Access Compliance Report

Public Rights-of-Way

(Curb Ramps)

Intersection ID: N/A	Main Street: GLENBURN_LN	Cross Street: KINGAUSSIE	Location: NE
ADA ID: B709E4201C17	Ramp Type: PerpDiag	Initial Pass/Fail: Fail	Overall Compliance: No
		Severity Score: 8.75

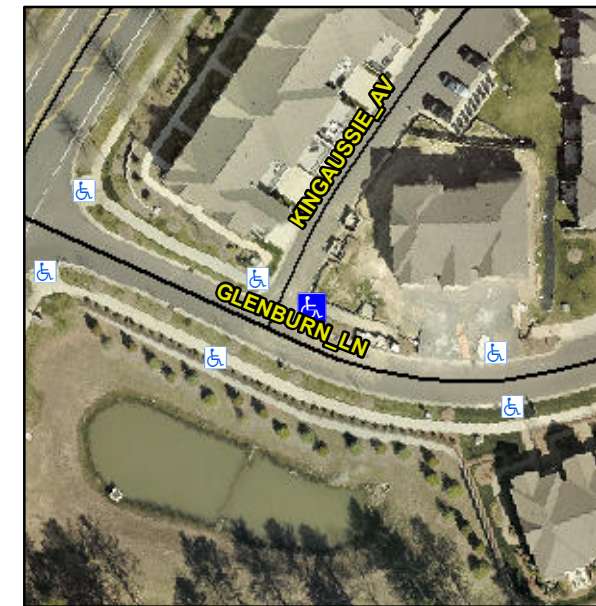
Not Found, R304.5.1

Compliance	Description	Data	Compliance	Description	Data
N/A	Ramp Length (in)	104.0	Yes	Ramp Slope (%)	7.9
No	Ramp Width (in)	43.0	Yes	Ramp XSlope (%)	1.2
N/A	Flare Type LT	N/A	N/A	Flare Type RT	N/A
N/A	Flare Slope LT (%)	N/A	N/A	Flare Slope RT (%)	N/A
N/A	Flare Traversable LT?	N/A	N/A	Flare Traversable RT?	N/A
N/A	Landing Length (in)	N/A	N/A	DWS Provided?	N/A
N/A	Landing Width (in)	N/A	N/A	DWS Contrast?	N/A
N/A	Landing Slope (%)	N/A	N/A	DWS Length (in)	N/A
N/A	Landing X Slope (%)	N/A	N/A	DWS Full Width?	N/A
N/A	Landing Curb? (Y/N)	N/A	N/A	DWS Offset (in)	N/A
N/A	Shared Landing?	N/A			
N/A	Gutter Ponding?	N/A	N/A	Gutter Slope (%)	N/A
N/A	Gutter Lip Ht (in)	N/A	N/A	Gutter X Slope (%)	N/A
N/A	Painted X Walk1?	No	N/A	Painted X Walk2?	No
	X Walk 1 Direction	To NW		X Walk 2 Direction	To SW
N/A	X Walk 1 Width (in)	N/A	N/A	X Walk 2 Width (in)	N/A
	X Walk 1 Slope (%)	0.8		X Walk 2 Slope (%)	2.1
	X Walk 1 X Slope (%)	2.0		X Walk 2 X Slope (%)	0.9

Remove & Replace Curb Ramp With Two New Directional Ramps or Equivalent.
